FPL Energy
Seabrook Station

Docket No. 50-443

SBK-L-06071

Seabrook Station
Reactor Vessel Weld Wire Material Data Update

UNIRRADIATED WELD

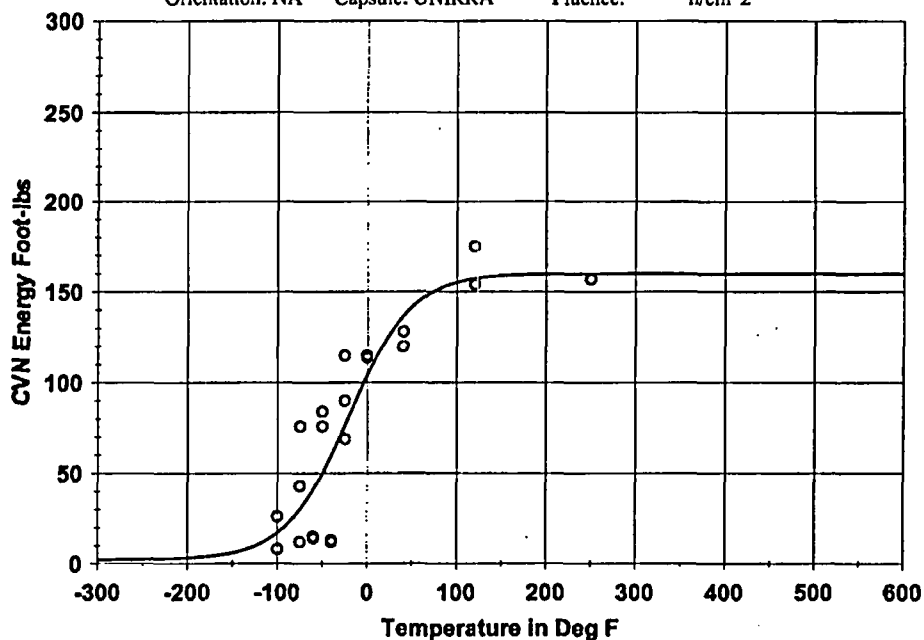
was 160 ft-lbs. Therefore, the USE value reported in WCAP-16526² for the beltline weld is 160 ft-lbs as required by ASTM E-185-82³, which is different than the 156 ft-lbs. previously reported in Seabrook Stations Generic Letter 92-01 response. The unirradiated USE values for weld heat 4P6052 from Reference 2 are attached.

FPL Energy Seabrook, LLC requests that the NRC revise the RVID2 database for the 4P6052 surveillance weld metal initial USE value and best estimate copper and nickel values. These revised values do not affect the results of our current analysis as submitted in FPL Energy Seabrook letter SBK-L-06070, "Reactor Vessel Surveillance Capsule Report," dated April 10, 2006.

Upper Shelf Energy=160.0(Fixed)
